Crown Street, Phase 3 – Manchester

DESIGN & ACCESS STATEMENT - ADDENDUM | APRIL 2024
Z1-SHP-A180-RP-XX-B5D803 | REVISION X03

Unit C7-1

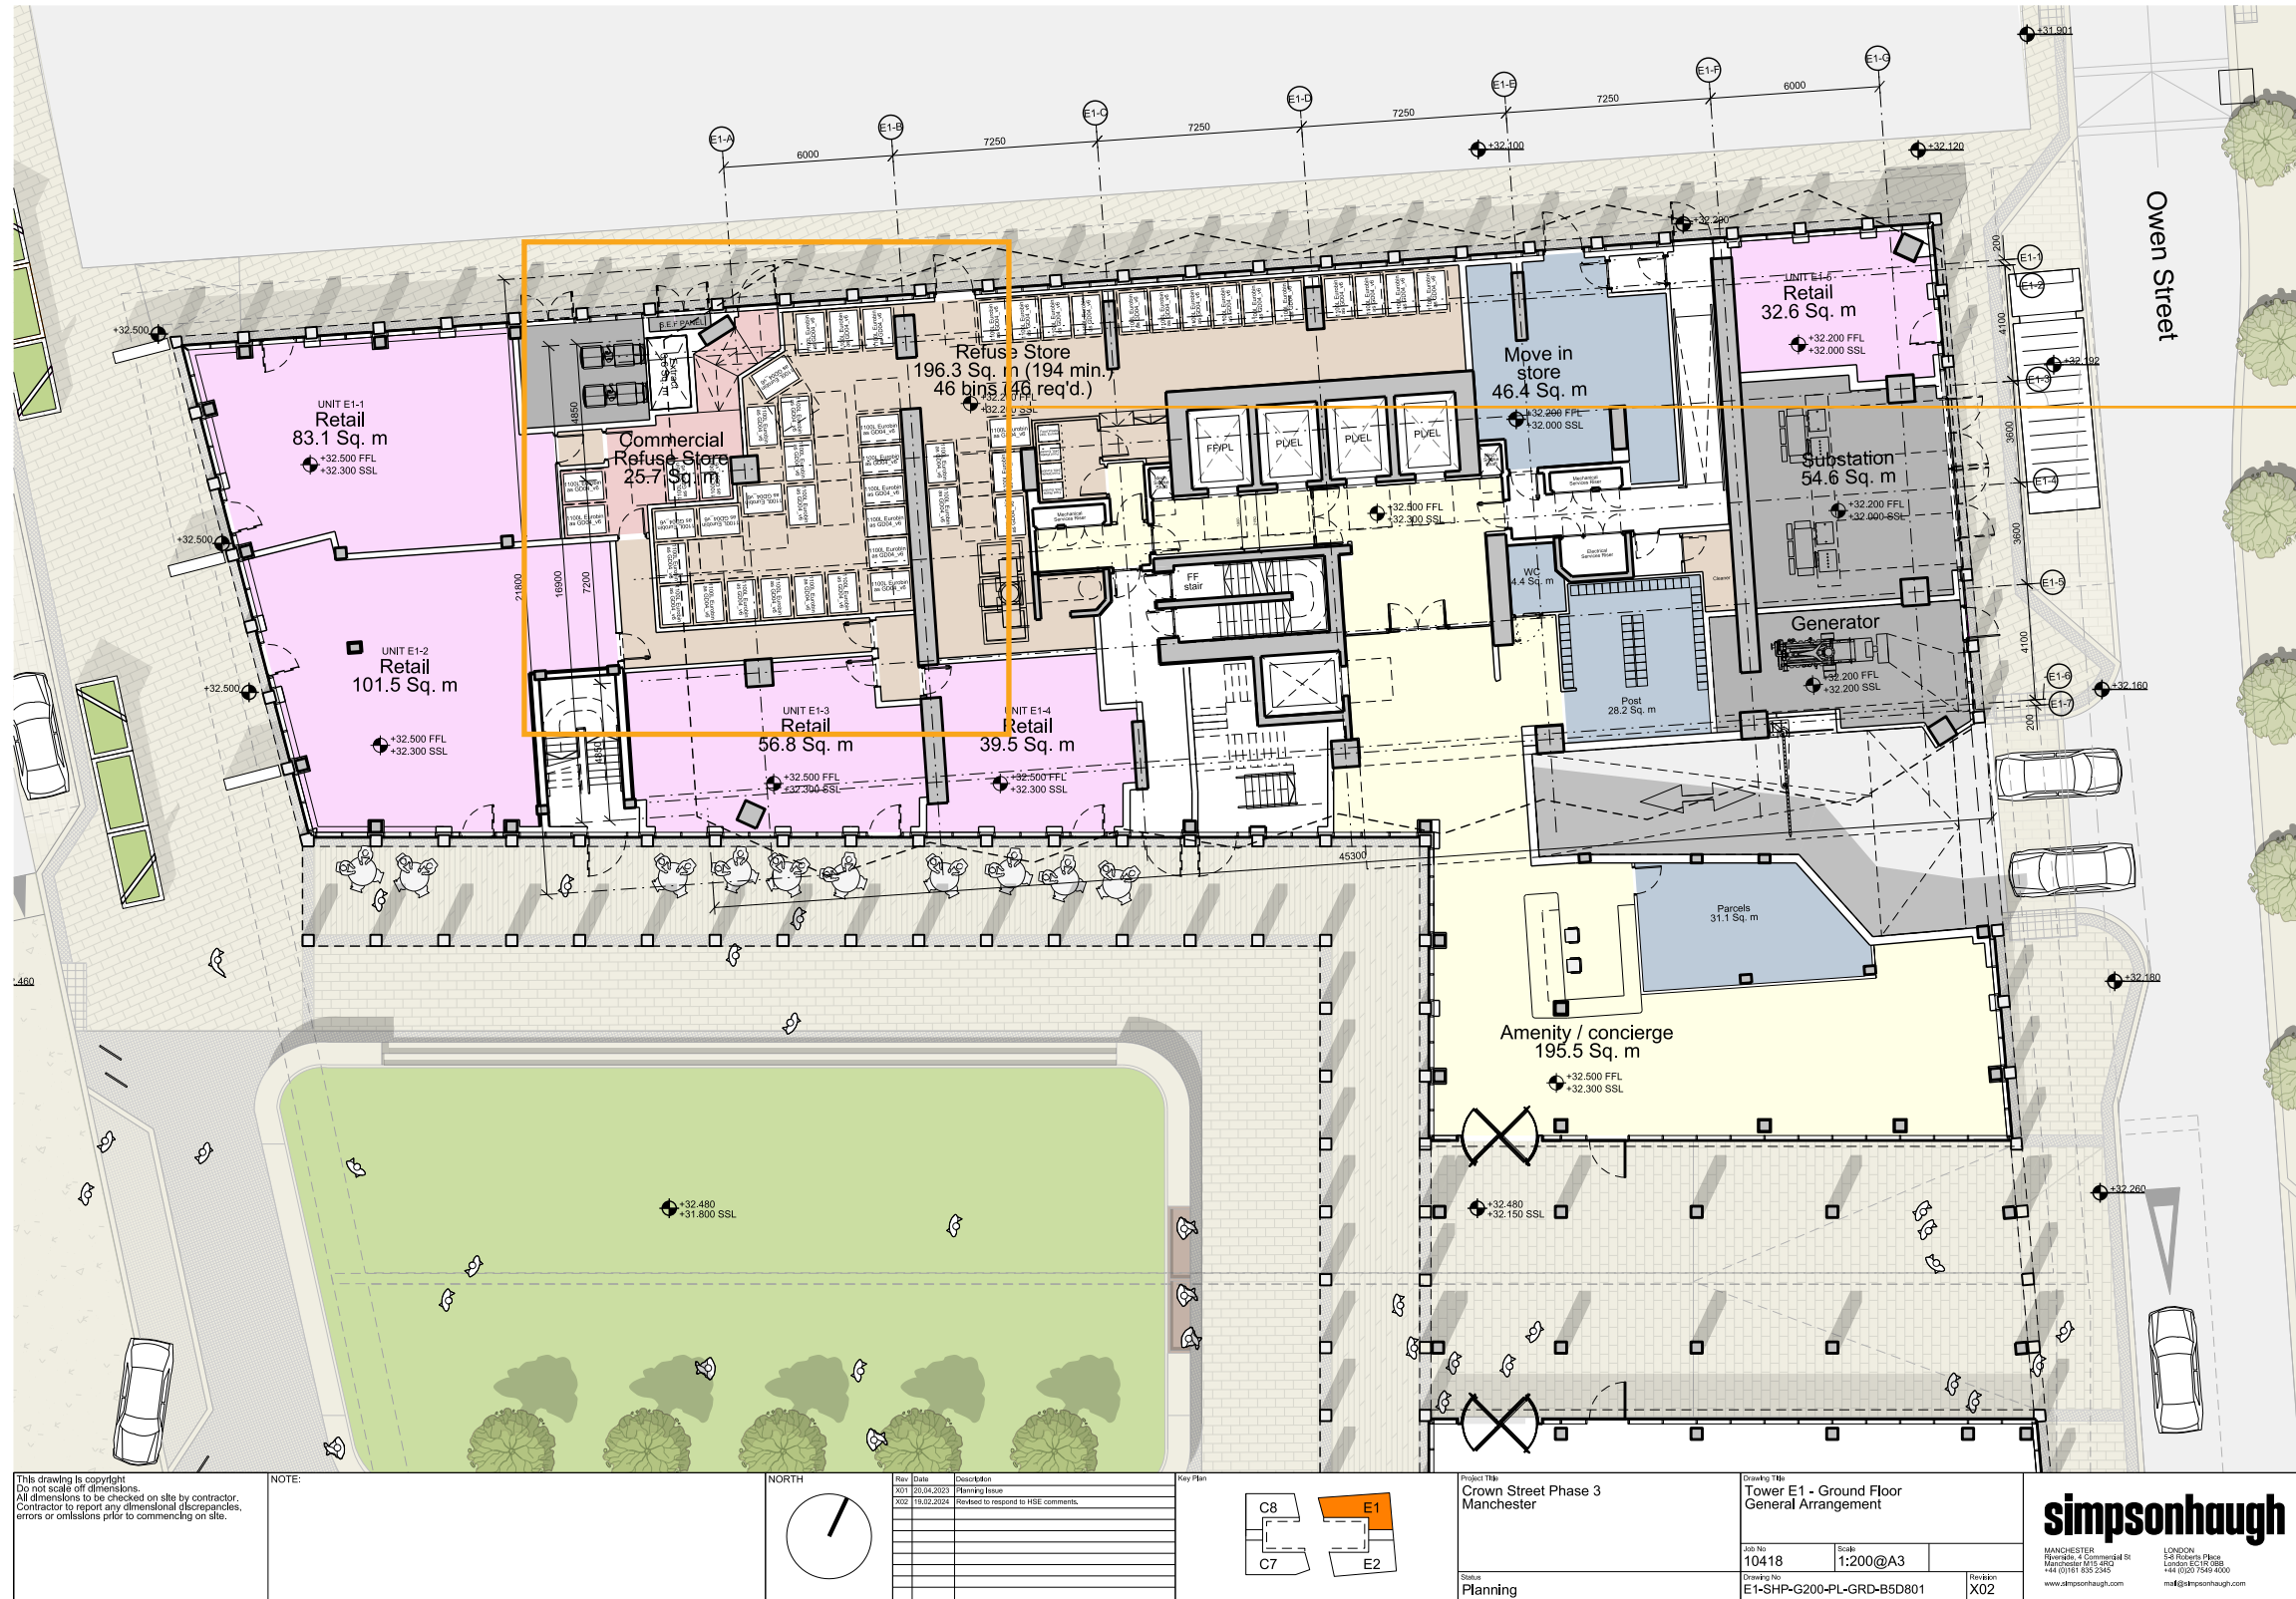
It is noted that commercial units C7-1, E1-1, 2, 3 and 4 and E2-2 link to the residential accommodation by way of the refuse holding stores and lobby to the fire-fighting stairs.

1.6. Whilst it is noted that the stair to the ground floor commercial and the stair to the residential floors are separated by lobbies at ground floor, the adopted fire safety standard states:

“Any stair serving a dwelling within a mixed-use development should not communicate with any other occupancy, unless in accordance with a) or b)...a) In buildings having not more than three storeys above ground or access level (small buildings), common stairs that serve both dwellings and other occupancies should be separated from each occupancy by protected lobbies at all levels. b) In buildings having more than three storeys above ground or access level: 1) all stairs serving dwellings, which are not ancillary to the main use of the building, should not communicate with any other occupancy in that building...”

Accordingly, the lobbied communication of commercial and residential staircases is not appropriate as the development is not a small building. Design changes necessary to provide separated means of escape will affect land use planning considerations such as the layout and appearance of the development.

A fire-separated corridor and independent refuse store has been created for Unit C7-1 to remove the link between the commercial unit and residential accommodation.

A fire-separated corridor and independent refuse store will be created for Unit C7-1 to remove the link between the commercial unit and residential accommodation.

Amendments in response to HSE comments.

PROPOSED FEBRUARY 2024

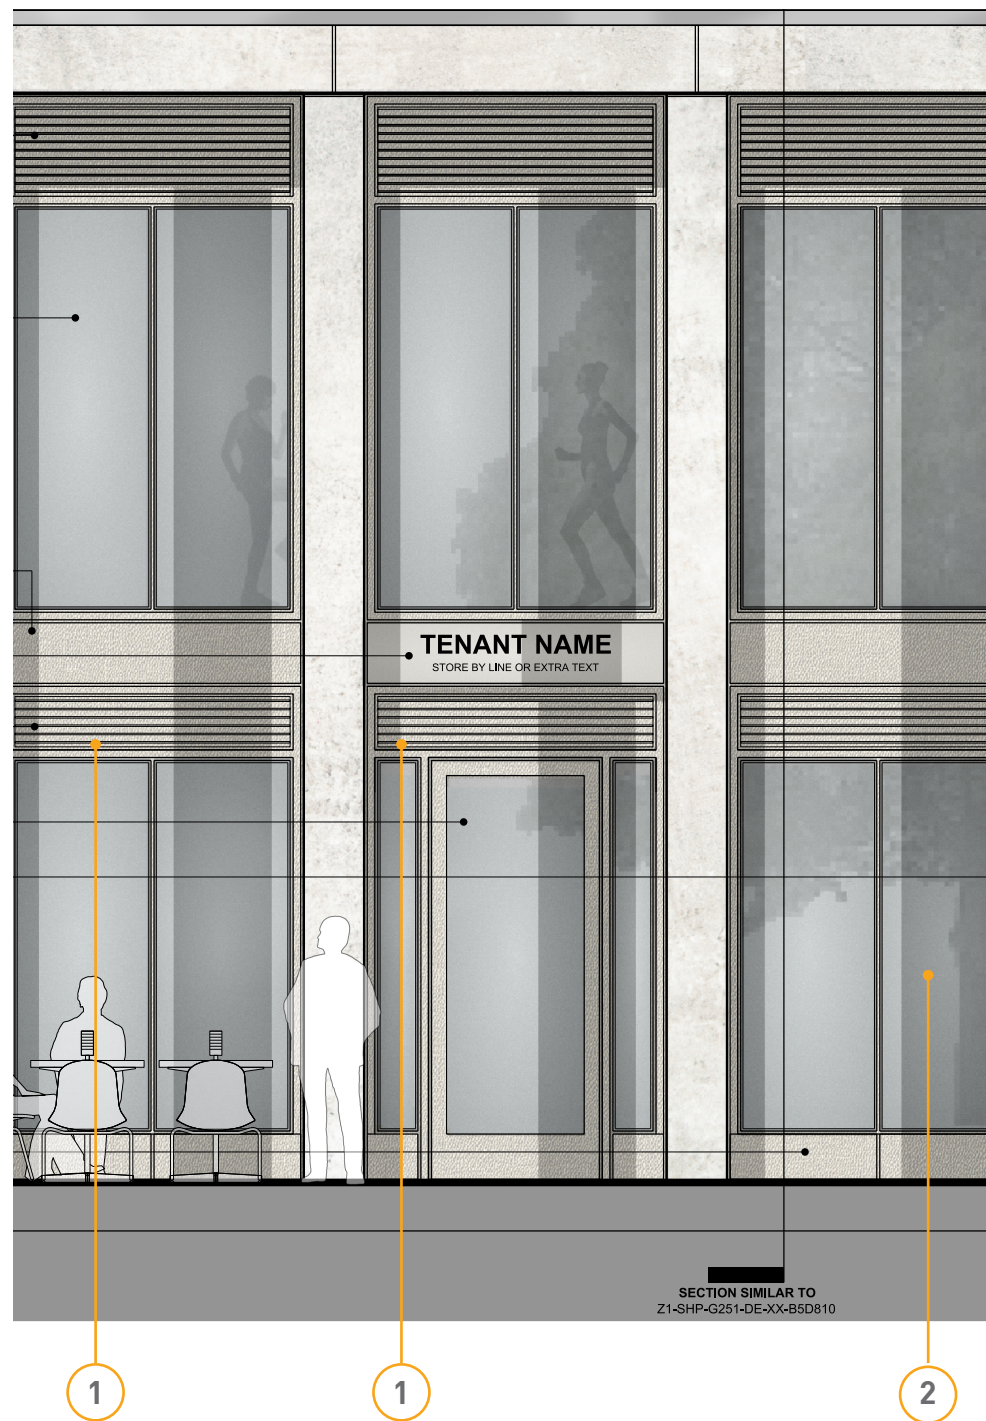
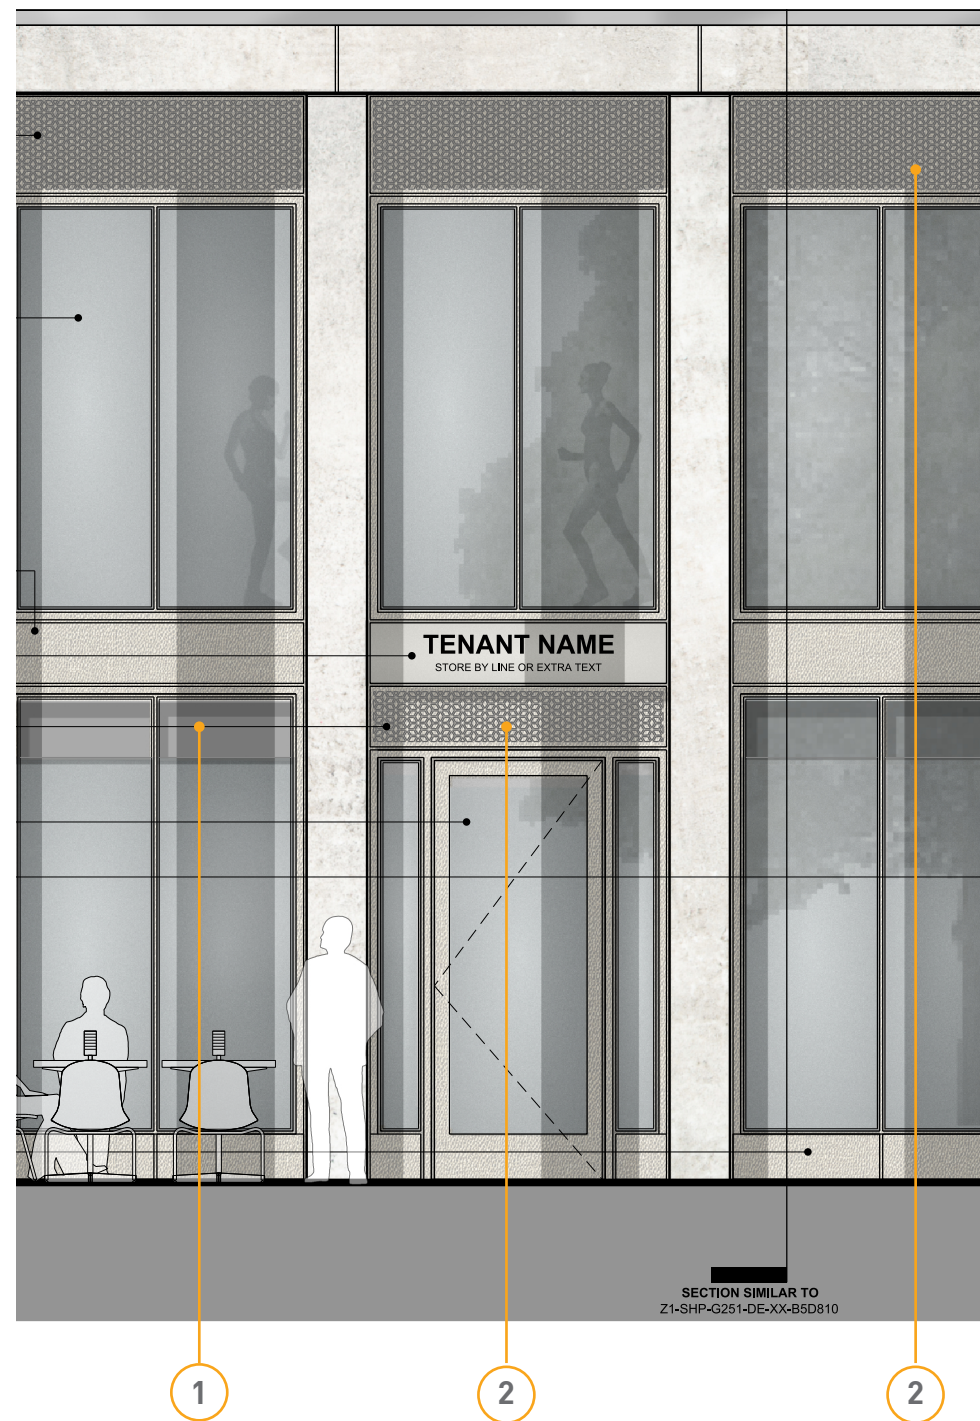
Please would you also look at replacing/screening the louvres around the waste storage and substation/plant areas with more decorative perforated panels (eg to match those used for purge vents on the upper floors of the building).

Continuous high level louvre band at ground and first floor.

1. Louvre
2. Clear glazing

1. Louvre removed where possible, glazing extended to full height (*bulkhead behind*)
2. Anodised perforated sheet in front of remaining louvres

In response to comments received from MCC, the design team have reviewed the overall louvre provision across the podium levels with a view to mitigating the visual impact against the following hierarchy:

For visual continuity, and to maintain a degree of flexibility, the original proposal submitted at planning incorporated a consistent band of high level louvres at ground and level 01. Wherever possible, in response to MCC's comments the design team have explored options to reduce the number of louvred panels.
